RE: Narrative for Application of Eastern Ave Holdings, LLC for a Proposed Parking Lot at 233 Eastern Boulevard – Planned Employment Zone & Groundwater Protection Zone 1

Rock Gym - Response to Commissioner Kaputa's Questions

SITE PLAN/EROSION & SEDIMENTATION CONTROL PLAN
#259 & #233 EASTERN BOULEVARD
PREPARED FOR
CENTRAL ROCK GYM
GLASTONBURY, CONN.

SITE PLAN/EROSION & SEDIMENTATION CONTROL PLAN
#259 & #233 EASTERN BOULEVARD
 PREPARED FOR
CENTRAL ROCK GYM
 GLASTONBURY, CONN.

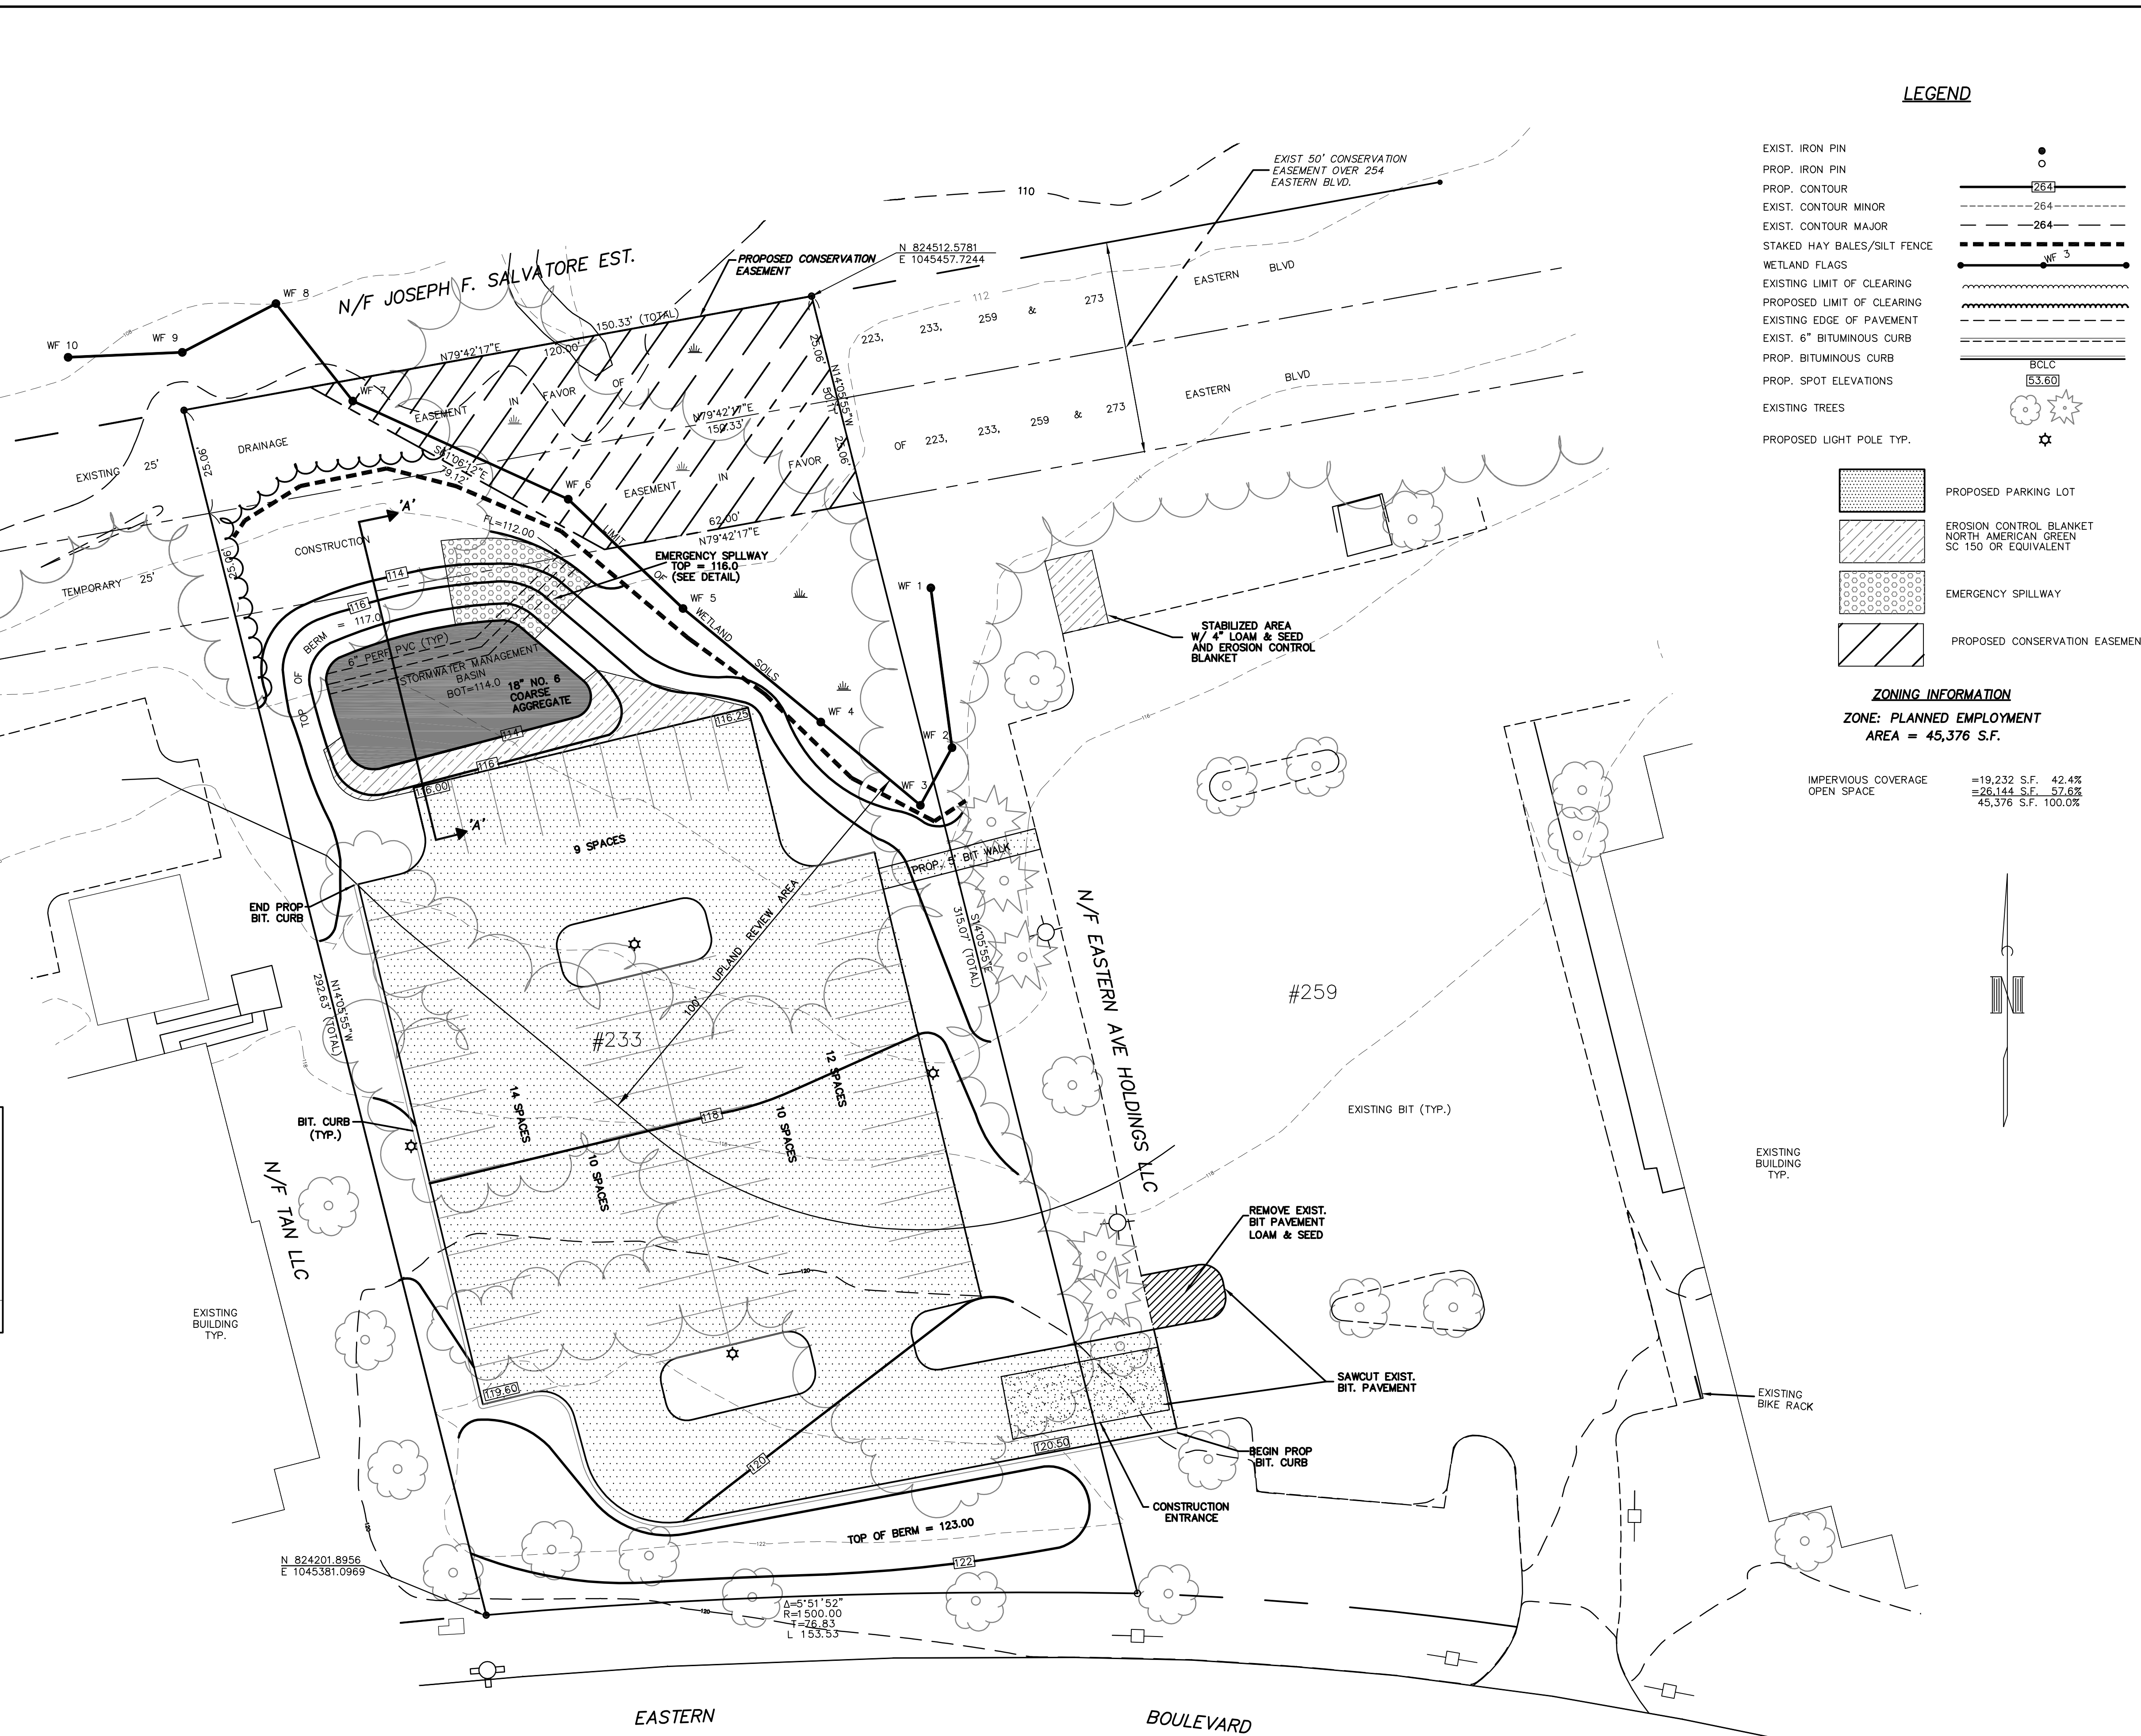
"Commissioner Kaputa asked the question about the existing parking on the northwest corner and pointed out it looks like erosion is going into the wetlands. Attorney Alter responded he had no idea but would find out. Commissioner Kaputa also noted that on the same property in the northeast corner there is a drive with cuttings and trees knocked down near wetlands. He asked Attorney Alter what was going on there."

Following the meeting, I discussed this issue with my client. He indicated that over the past several months patrons of the gym began to park on the shoulders of the parking lot due to the lack of available parking within the existing lot. The manager was unaware that these areas were in the upland review area. Mark Friend did review the Site in person and indicated to me that the area that was disturbed did not extend into the existing Conservation Easement area. With the approval of the new parking lot, the owner does not see this issue happening again.

On May 29th, the areas that were disturbed were cleared of any piled brush, and loamed and seeded. The areas are currently being watered twice a day and grass is already growing in those areas. Mark indicated that there is a very small area in the northwest corner of 259 Eastern Boulevard that will require an E & S blanket in order for grass to grow - he has added this detail to Plan.
